Addendum 127 – UN Regulation No. 128

Amendment 7

Supplement 7 to the original version of the Regulation – Date of entry into force:
16 October 2018

Uniform provisions concerning the approval of light emitting diode (LED) light sources for use in approved lamp units on power-driven vehicles and their trailers

Figure 1
Enlargement of the nominal emitter box

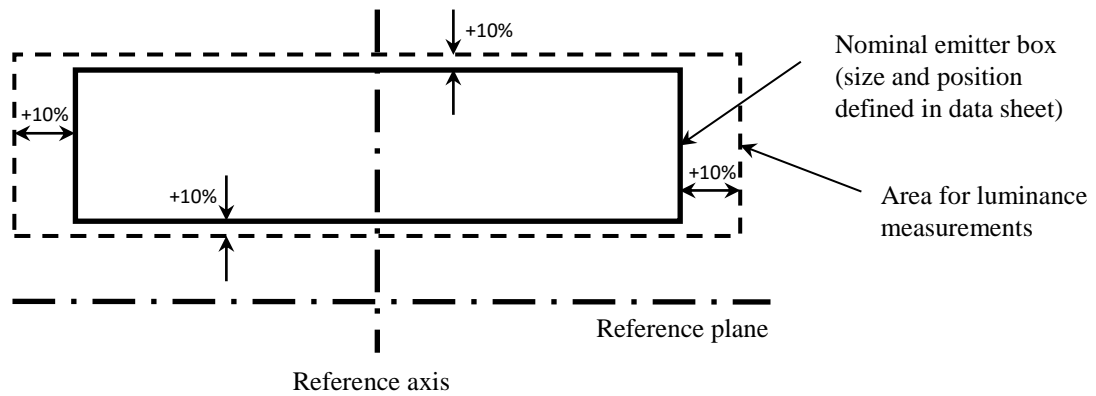
Insert a new Annex 9, to read:

2. The luminance measurements of an area shall be done in an equidistant grid in both directions.
3. Zone 1a and zone 1b shall be determined from luminance measurements of an area which consists of the nominal emitter box as specified in the relevant data sheet of Annex 1 and enlarged to all sides by 10 per cent of the corresponding box dimension (see figure 1). The value L_{98} is the 98th percentile of all values of these luminance measurements.

Figure 2
Definition of zones 1a and 1b

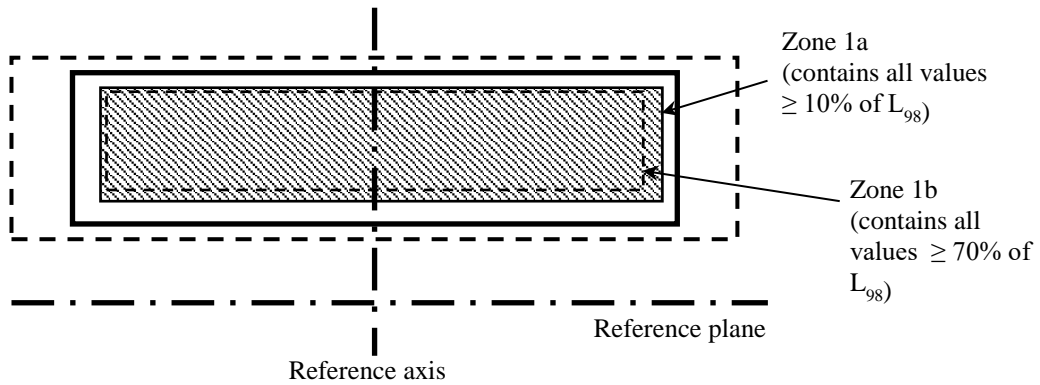
- 3.1. Zone 1a (light emitting area) shall be the smallest circumferential rectangle having the same orientation as the nominal emitter box and containing all luminance measurements with a value of 10 per cent or more of the value L_{98} . The value L_1 shall be the arithmetic average of the values of all luminance measurements in zone 1a (see figure 2). The value of $R_{0.1}$ shall be the surface ratio of zone 1a where the luminance value is exceeding 10 per cent of the value L_1 . The value of $R_{0.7}$ shall be the surface ratio of zone 1a where the luminance value is exceeding 70 per cent of the value L_1 .

- 3.2. Zone 1b shall be the smallest circumferential rectangle having the same orientation as the nominal emitter box and containing all luminance measurements with a value of 70 per cent or more of the value L_{98} .
